Los Angeles County
Metropolitan
Transportation
Authority

TO: MTA BOARD OF DIRECTORS
FROM: STANLEY G. PHERNAMBUCCO
SUBJECT: MTA CONSTRUCTION NONCONFORMANCE REPORTS

Attached please find copies of the Nonconformance Reports (NCRs) received by the MTA Director of Quality Management for the week of August 25 - 31, 1995.

1
CP-103

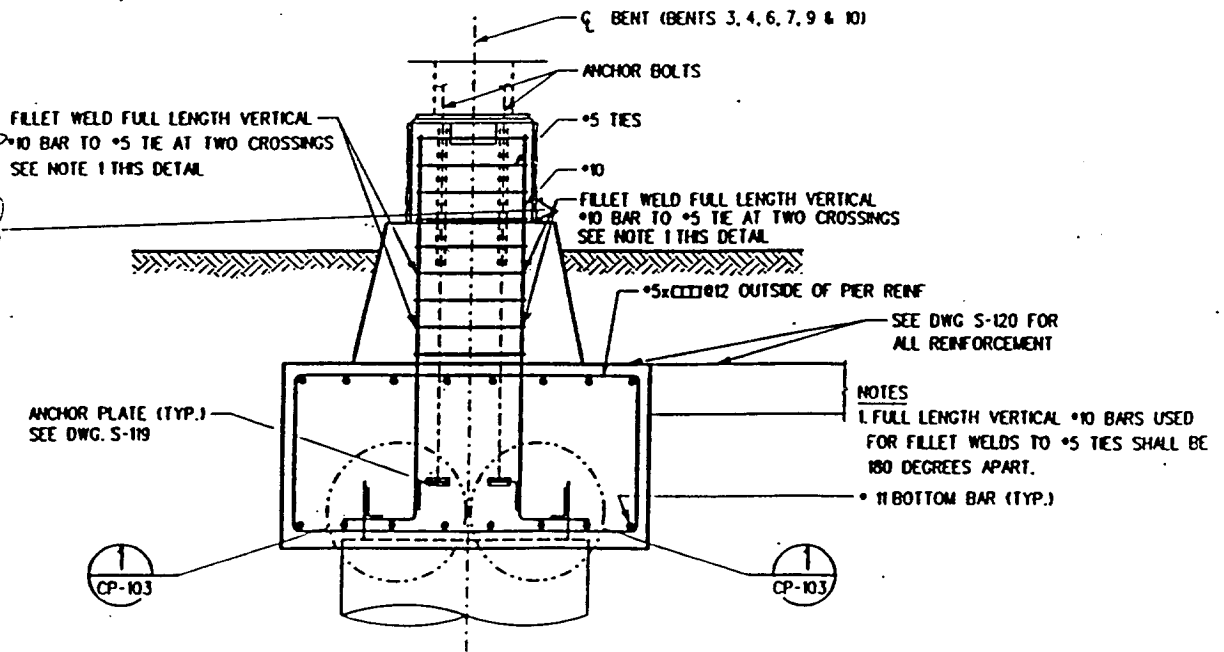
7. Specification/Drawing No.: <i>CP-103</i>			8. Originator: <i>Mohammad ALazzam</i> Phone Number: <i>(213) 258-7284</i>		
9. Nonconformance description and contract requirements: <i>Nationwide did not perform fillet welding on the pedestals for bents #6 & 7 (see the attached sheet). The pedestals are already poured & backfilled by Kiewit.</i>

tionwide didn't let weld these

ELEVATION - ABUT 12 INTERFACE RETAINING WALL (NORTH)

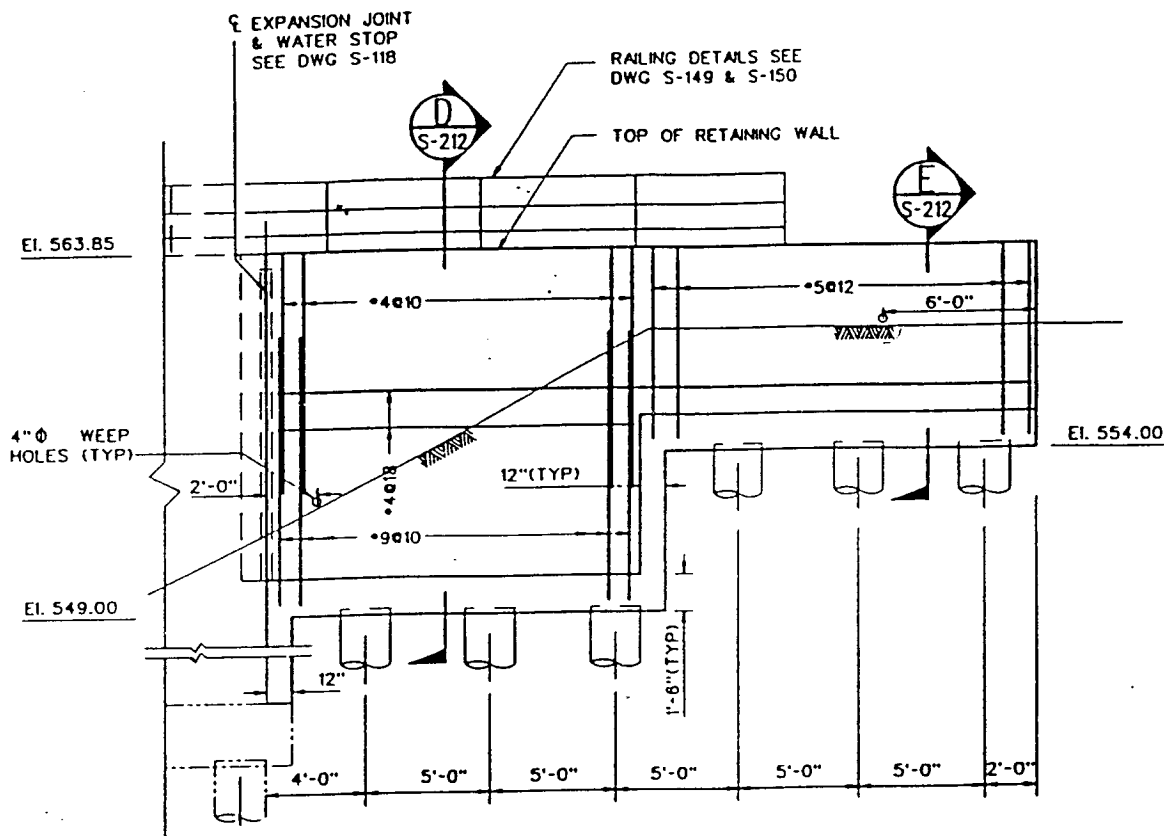
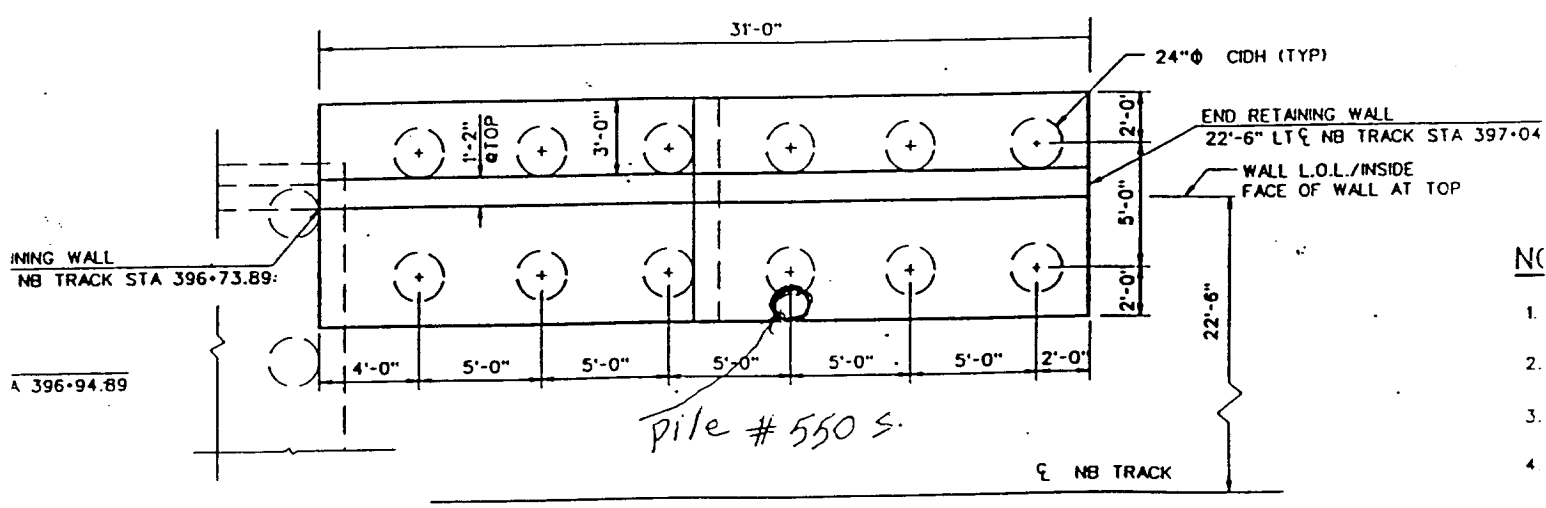
7. Specification/Drawing No.: <i>2387-1.2 E, plan sheet # 130</i>			8. Originator: <i>Mohammed Alazzah</i>		Phone Number: <i>(213) 258 7284</i>
9. Nonconformance description and contract requirements: <i>The 24" CIDH pile # 550 S. constructed under abut. 12 interface wall (North) had been shifted toward the edge of the footing by 10" to 12" from it's corrected location according to plan sheet # 130 (see the attached sheet # 2 of 2)</i>
